**TOWN OF NEWBURGH
PLANNING BOARD
TECHNICAL REVIEW COMMENTS**

PROJECT NAME: GARDNER RIDGE
PROJECT NO.: 2-29
PROJECT LOCATION: GARDNERTOWN ROAD NEAR GIDNEY AVENUE
SECTION 75, BLOCK 1, LOT 4.12
REVIEW DATE: 10 JUNE 2022
MEETING DATE: 16 JUNE 2022
PROJECT REPRESENTATIVE: THOMAS B. OLLEY, P.E., P.L.L.C.

The following items are in response to comments in the Creighton Manning letter dated October 18, 2021. The items are numbered according to their review comments.

The following items are in response to comments contained in the MHE Engineering, D.P.C. letter dated October 21, 2021. The items are numbered according to their review comments.

SHEET NUMBER:
1 of 3

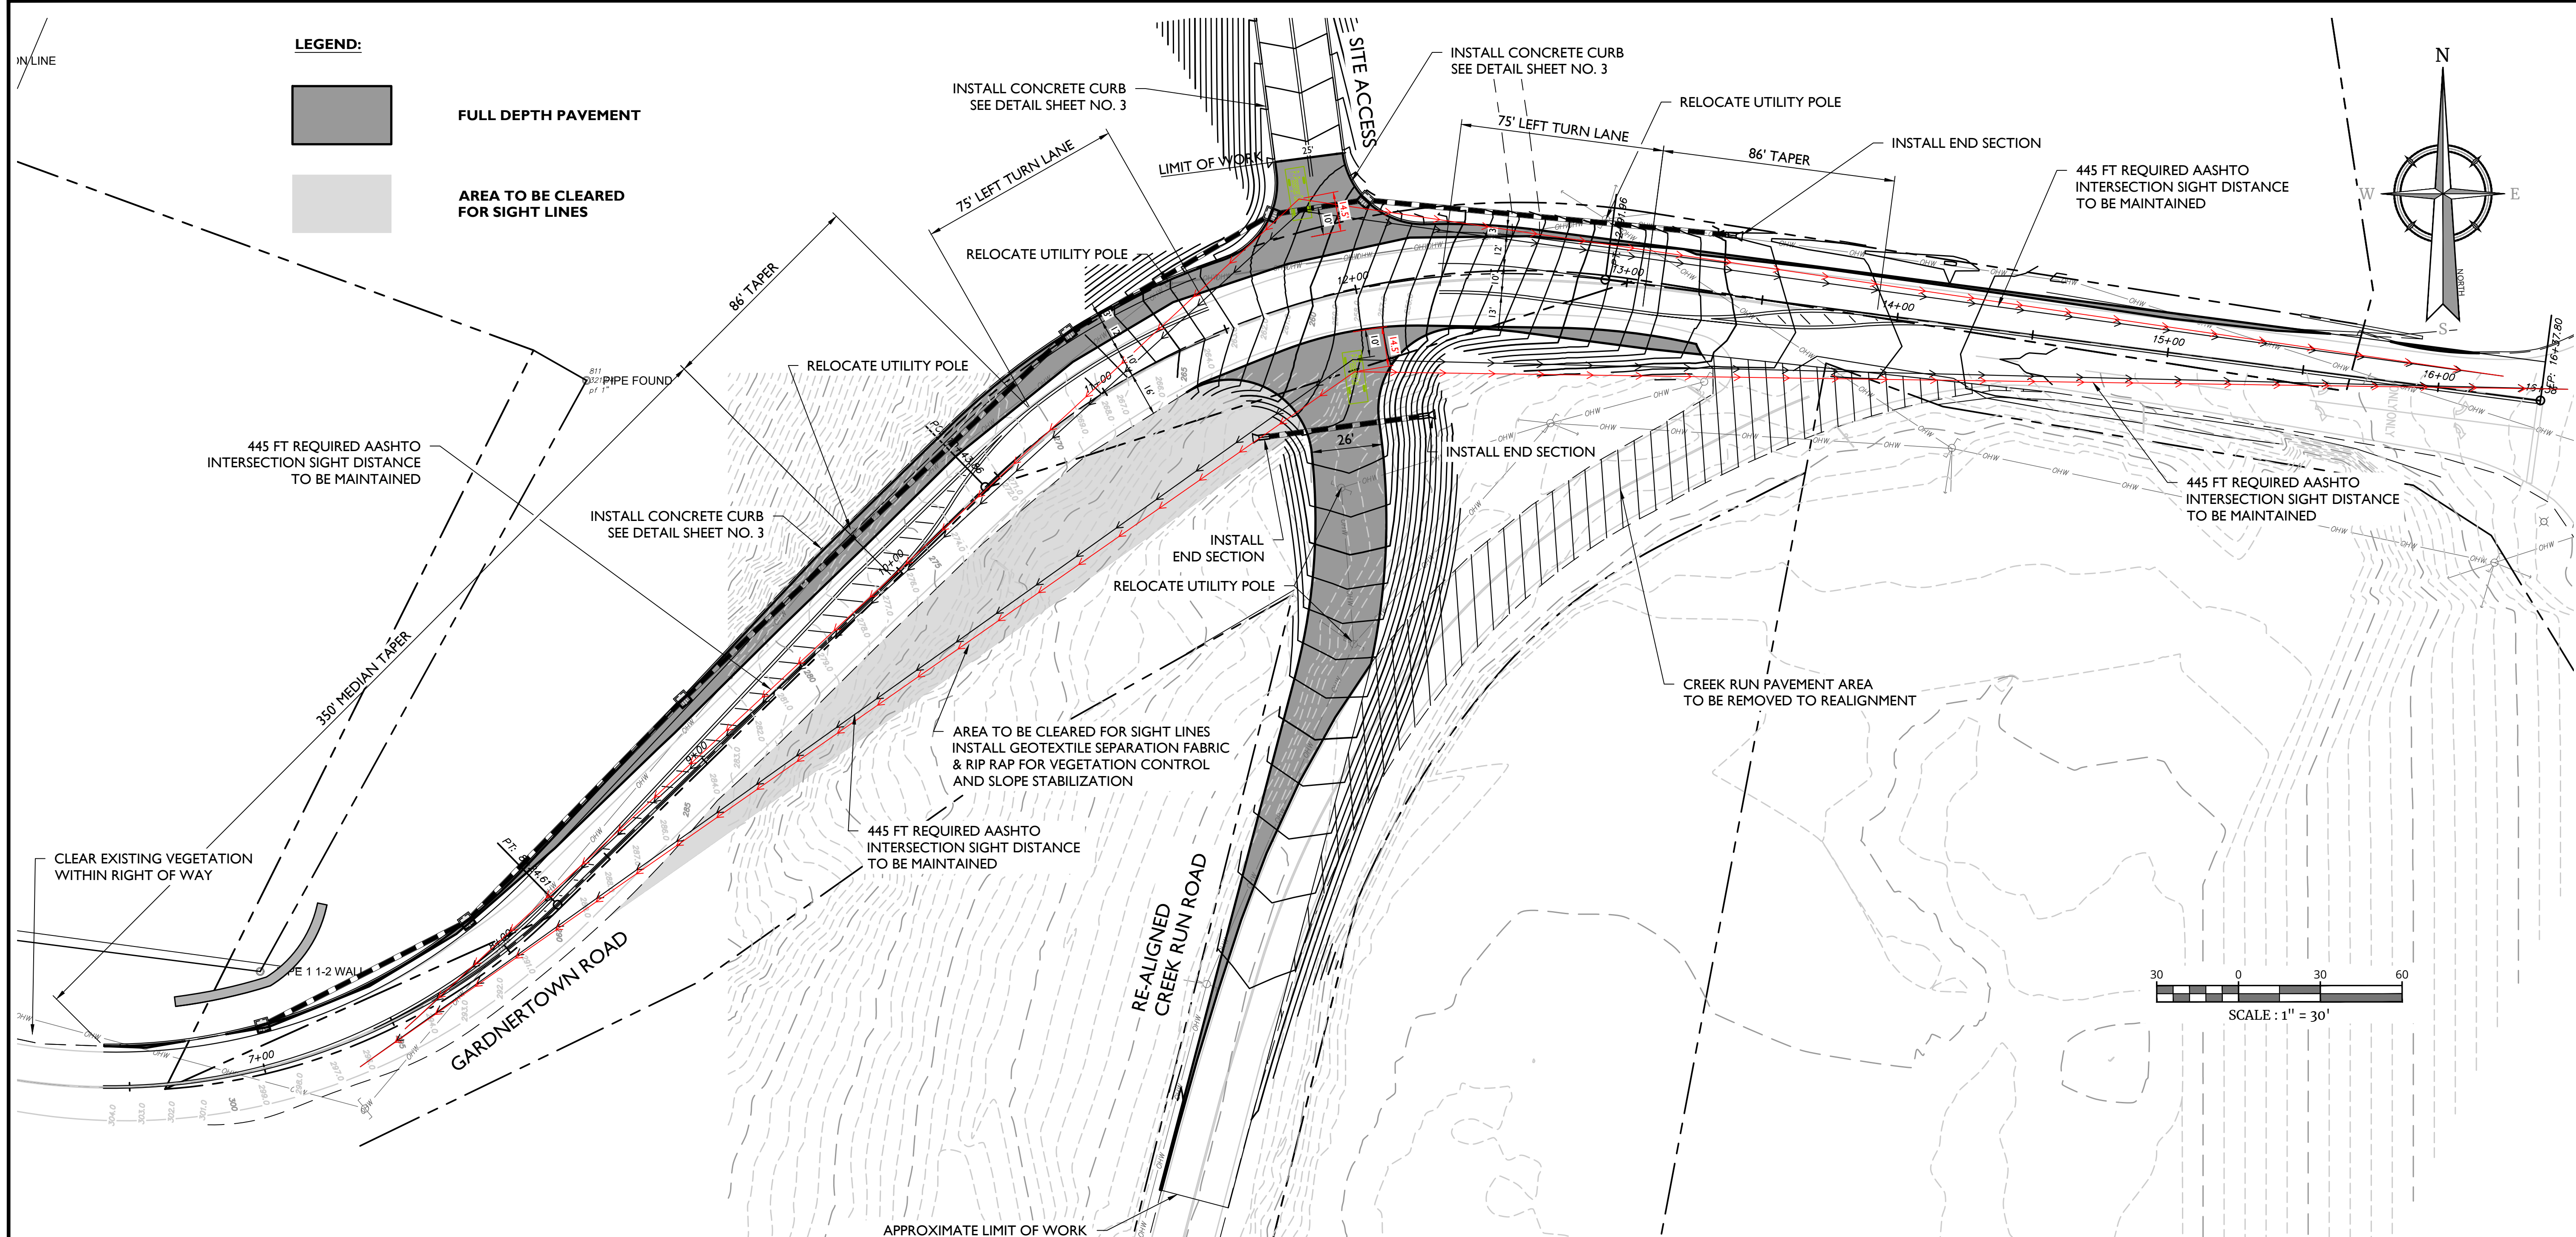
2. Extensive grading on the North side of Gardnertown Road is proposed. The plans depict a retaining wall to prevent grading onto private property. Construction of the retaining wall should be addressed with the Town of Newburgh Highway Superintendent and Town Board. Location of the retaining wall appears to be very close to the property lines depicted on the plans. Grading appears behind the proposed retaining wall onto private property on the plan sheet identified as Sheet 1 of 3.

Response: The retaining wall along the westerly portion of the site along the Gardnertown Road frontage have been reviewed and will be adjusted so that it all will be contained within the existing right-of-way or on the lands the Applicant will be dedicating to the Town.

SHEET TITLE:
CONCEPT PLAN (LAYOUT ONLY)
 SHEET NUMBER:
2 of 3

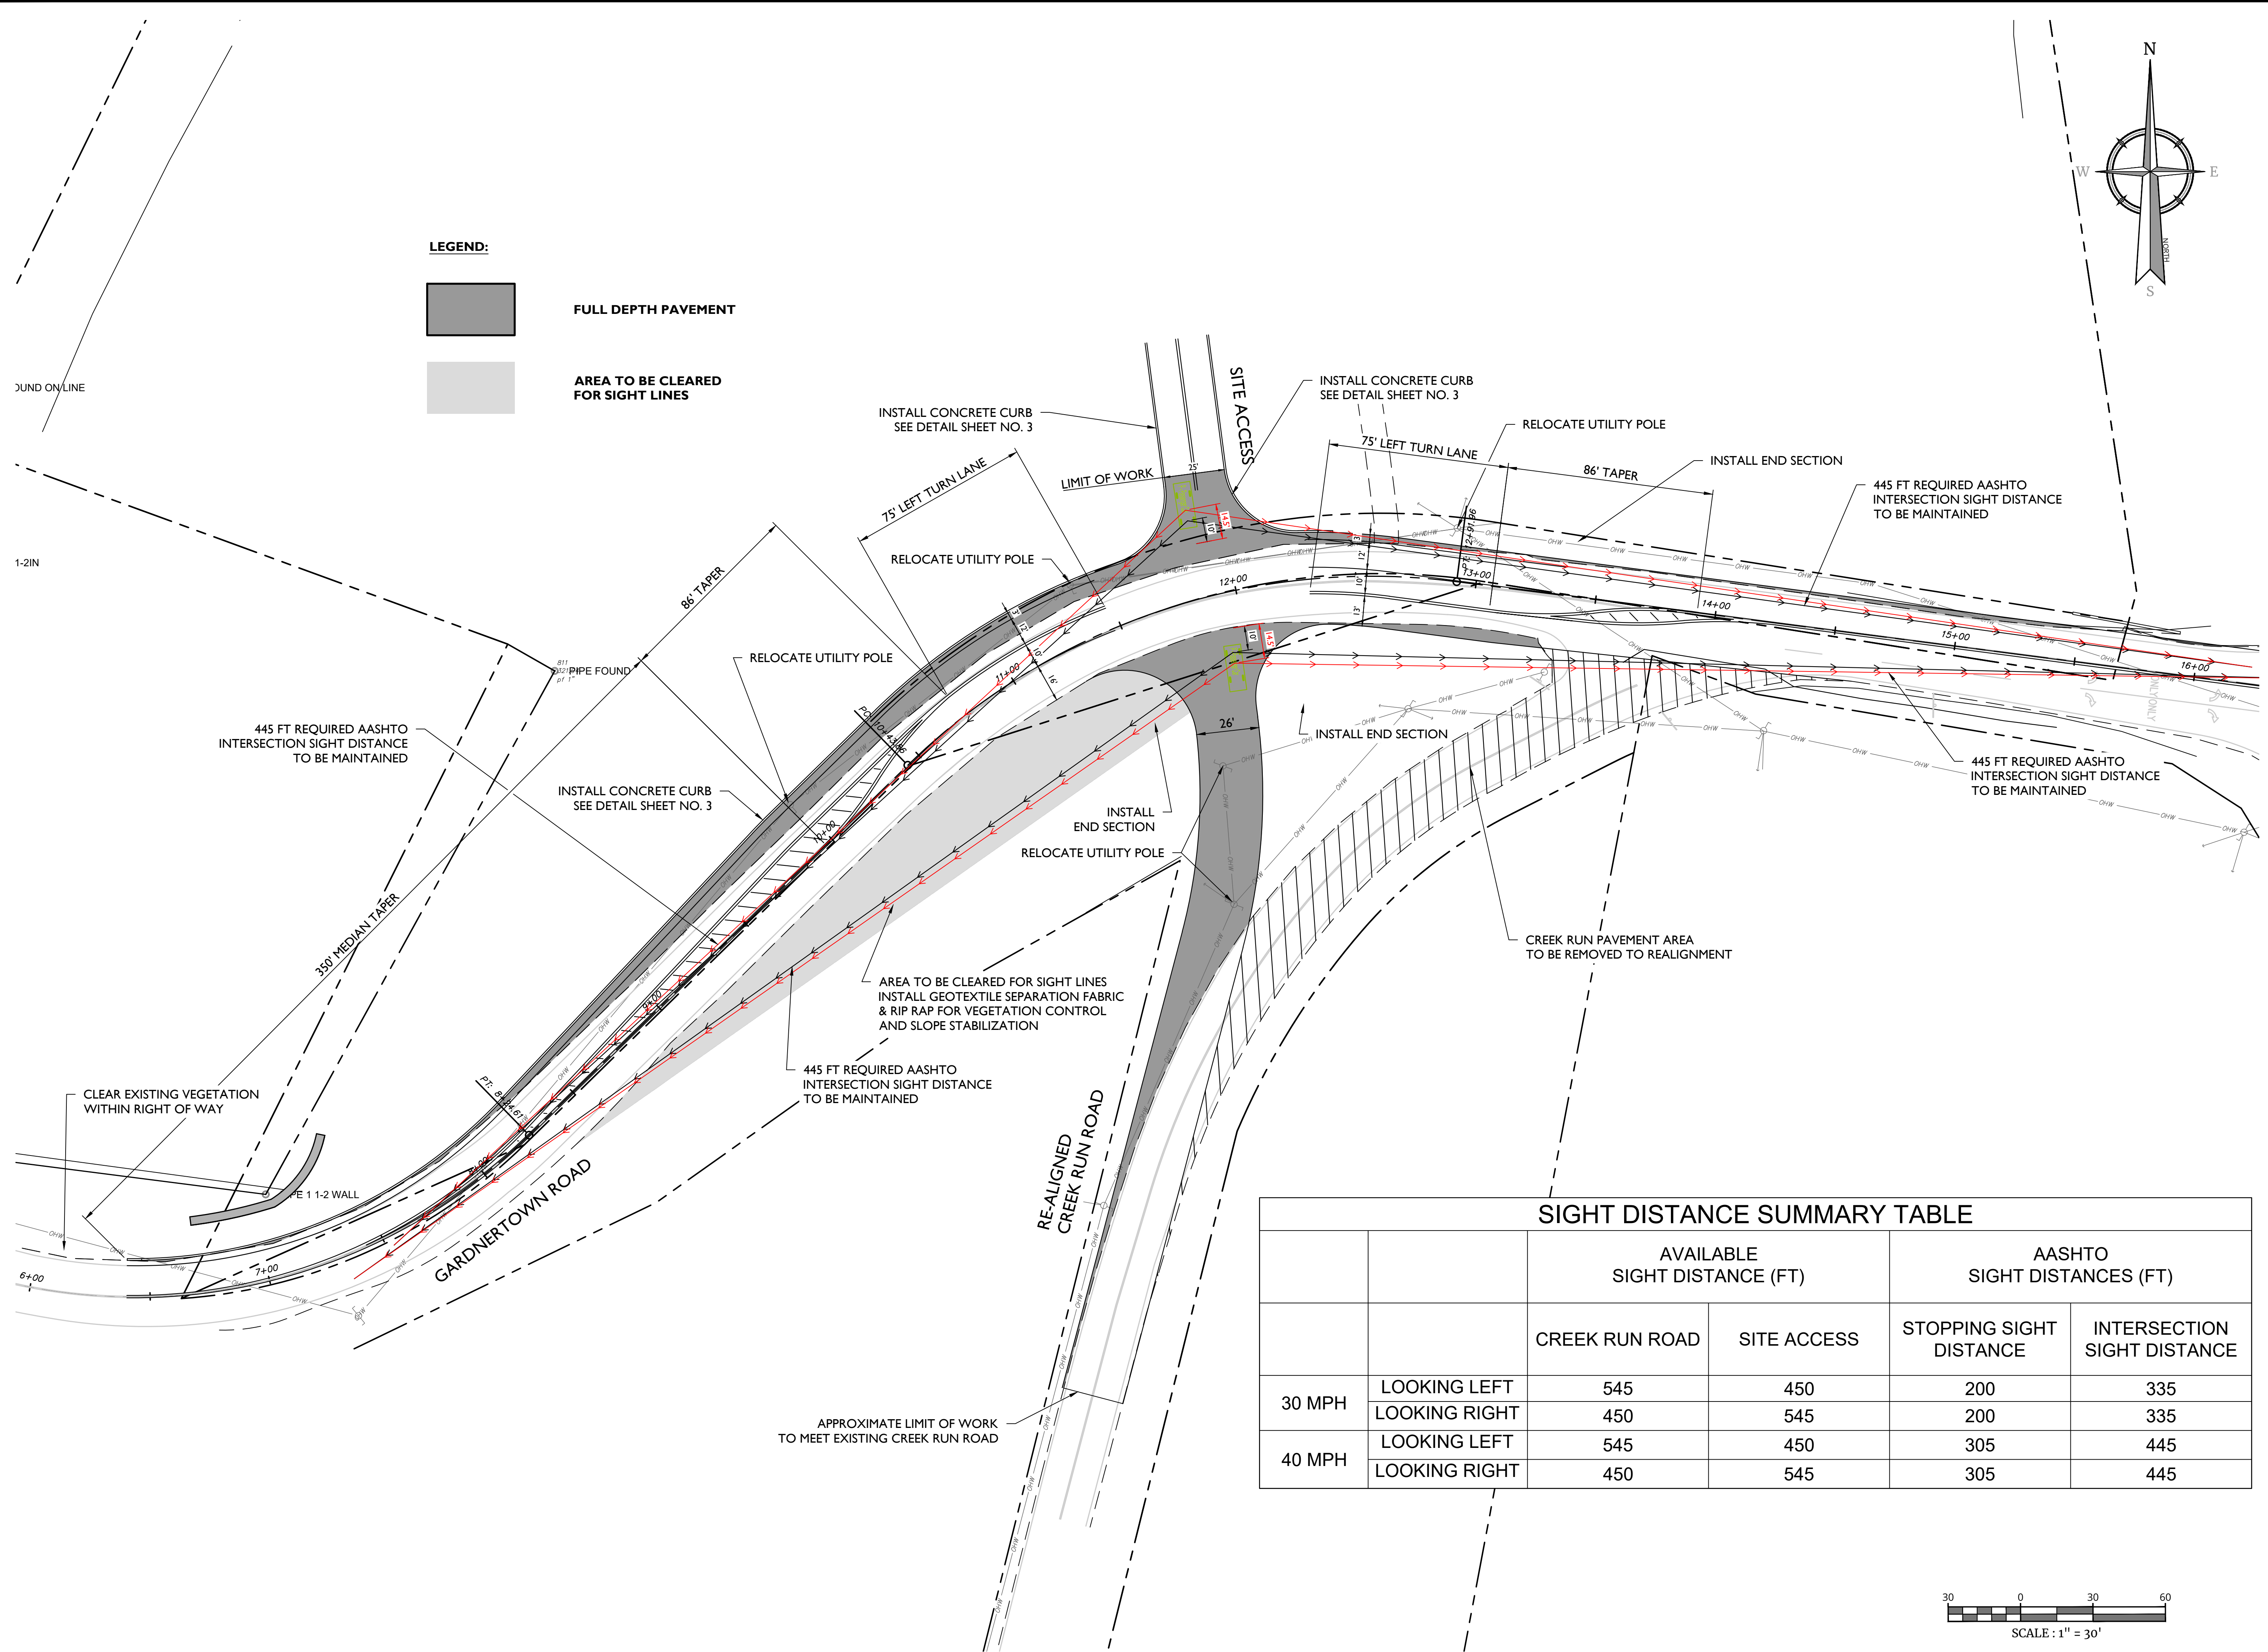
8. Sheet 2 of 3 shows the intersection sight distance triangles. The vertex triangles is offset 10 feet, but it's unclear from which point it's offset. The standard is to offset 14.5 feet from the edge of travel lane. Please clarify.

Response: This plan has been revised to show both the 10-foot offset as well as the 14.5-foot offset from the edge of travel way. The 10-foot offset represented the more likely position for vehicles to stop at; however, the 14.5-foot distance was used to develop the sight lines for the purposes of identifying the limits of vegetative clearing and grading, etc. Both lines are now indicated on the revised plan.

SHEET NO.
3 OF 14
 DATE: JANUARY 28, 2016
 FILE NO.

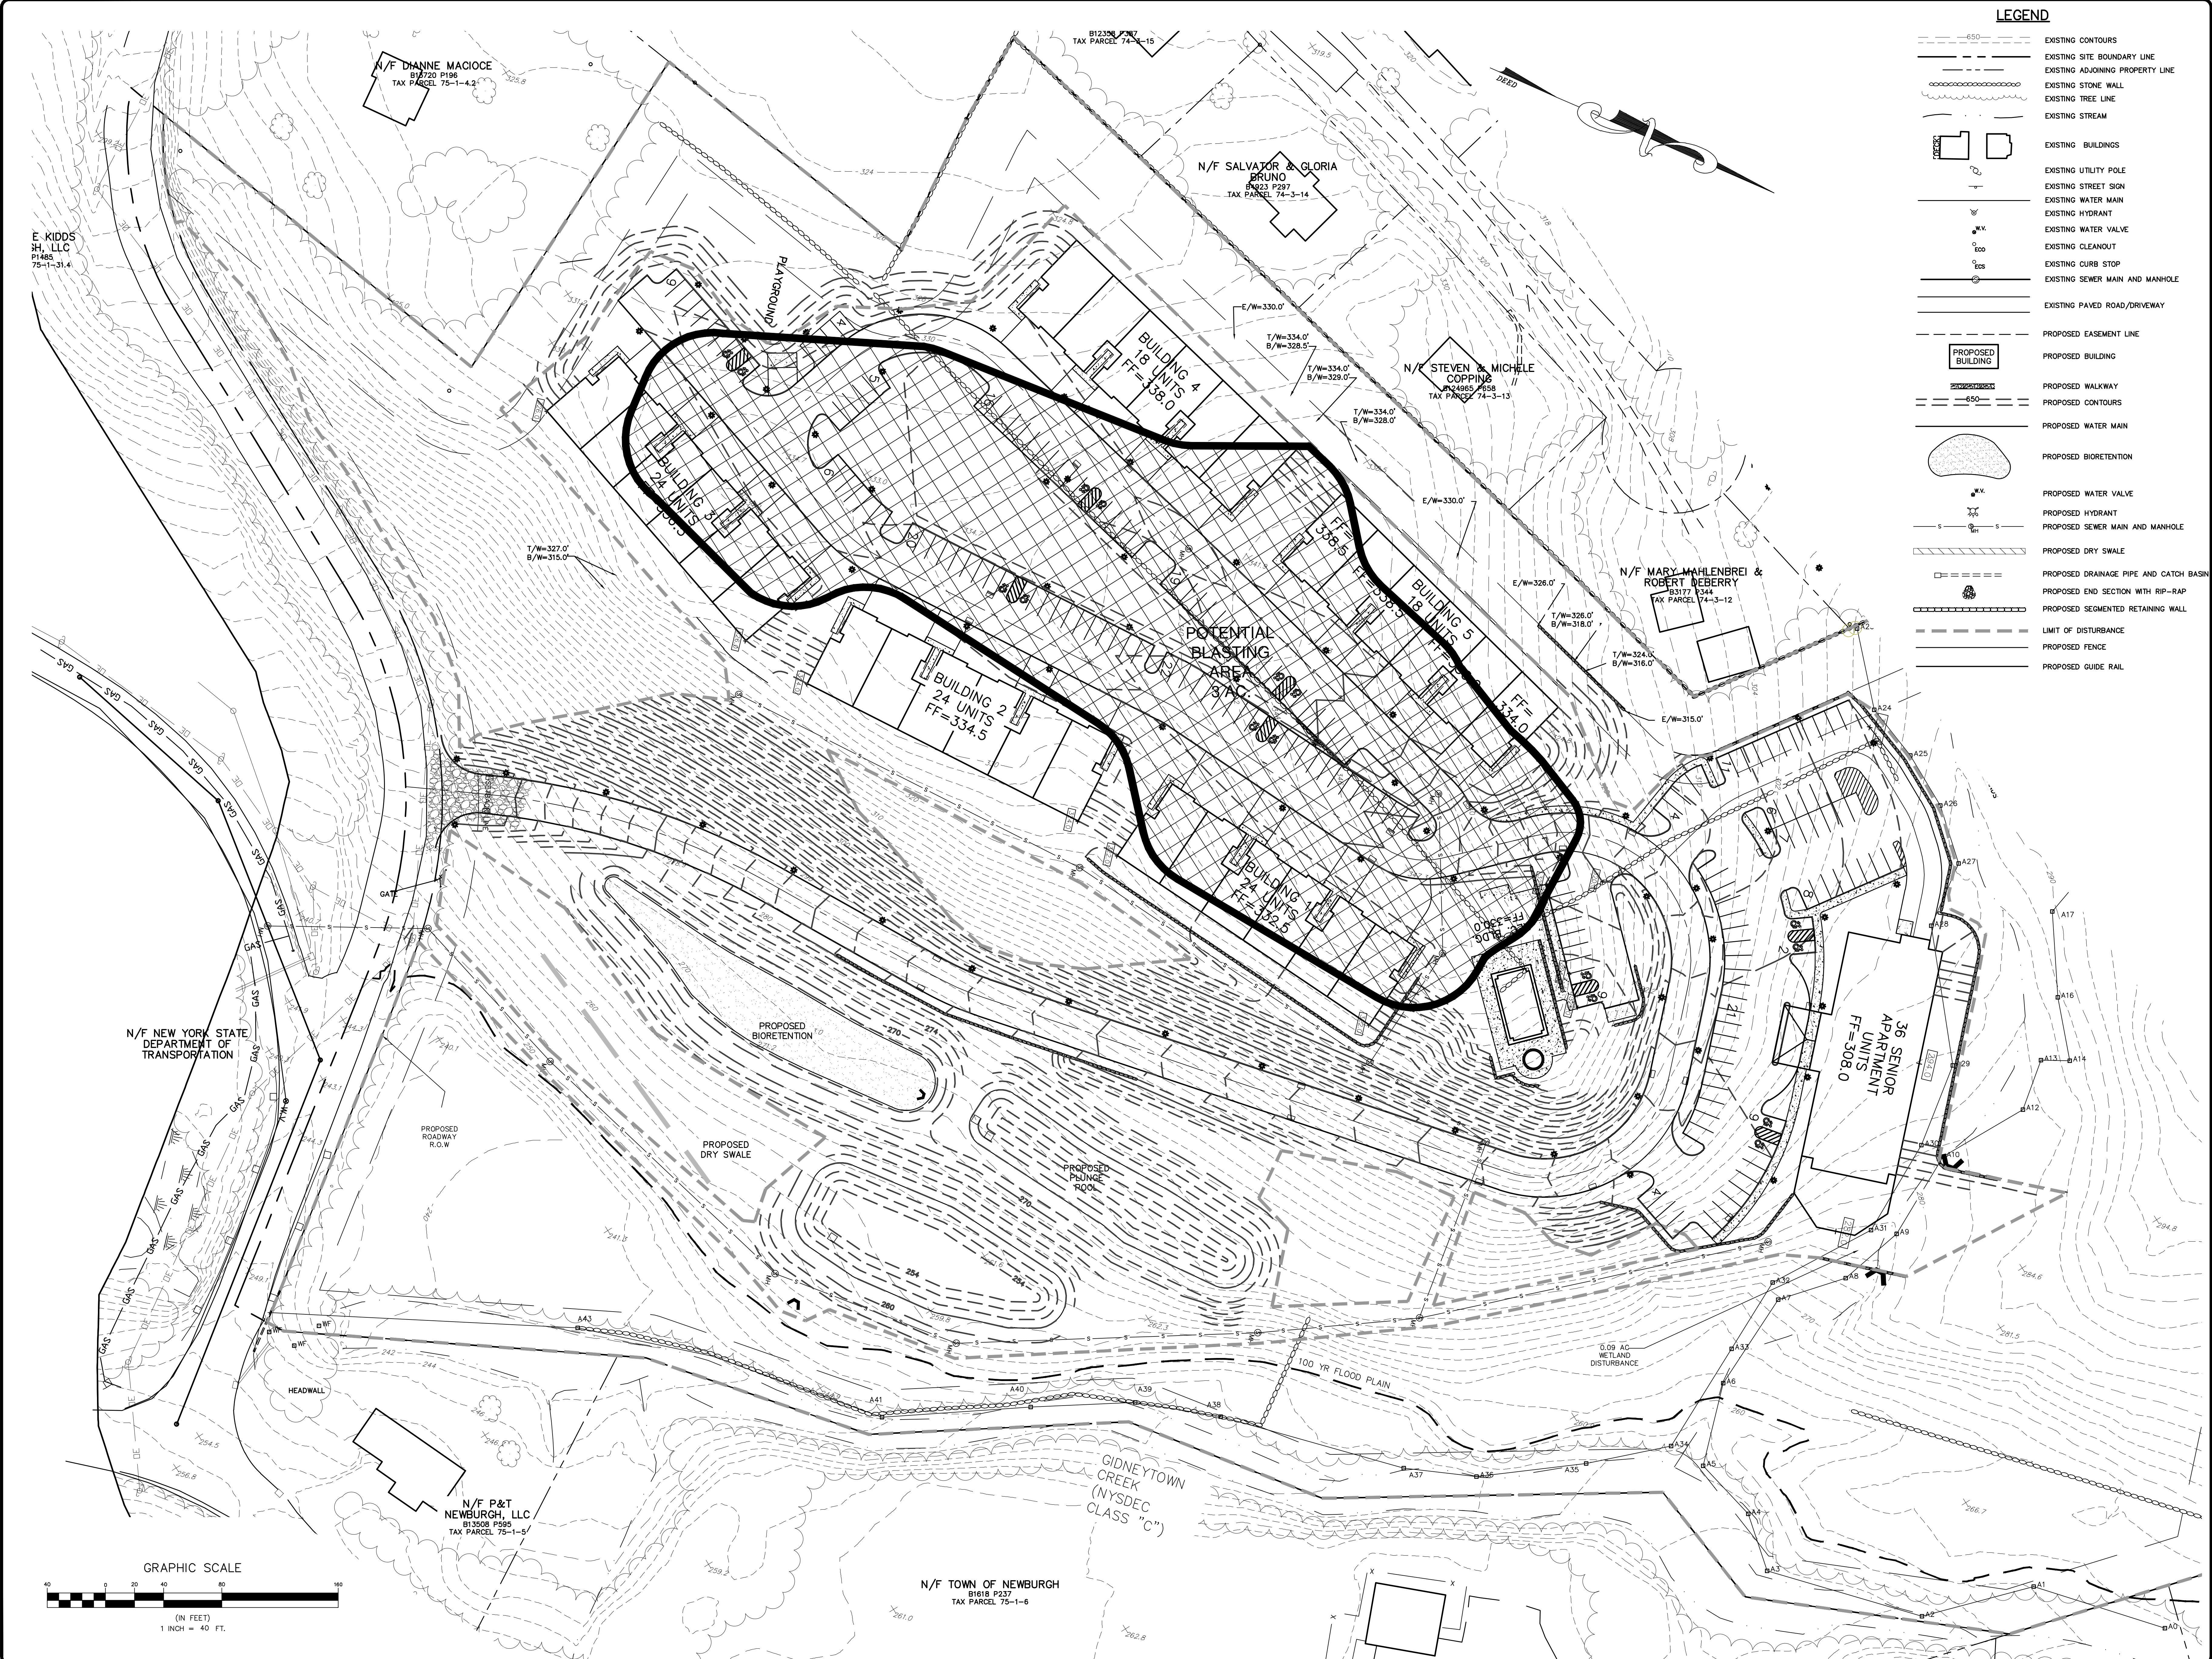
7. Status of the Army Corps of Engineers jurisdictional determination for the wetlands delineations on the site should be identified.
8. Sheet 3 of 18 identifies catch basins in sanitary manholes in a different configuration as other plan sheets. Sanitary manhole 6, catch basin B5-2 and -6 should be re-evaluated.
